# IMPORTANT SAFETY RECALL

## Re: Can-Am® Spyder® roadster - Fuel Cap Replacement – Re-Notification

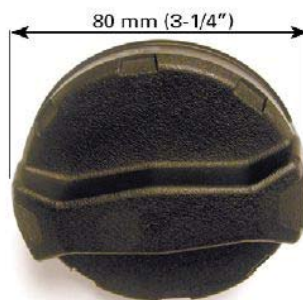
The fuel cap may not seal properly the fuel tank filler neck. Fuel vapors in the presence of an ignition source could result in a fire.

For reference, please see below pictures that will help you identify that the fuel cap on your vehicle is the improved version. The improved fuel cap has a reddish color seal and a different size handle. If your vehicle is equipped with the improved version, no further action is needed.
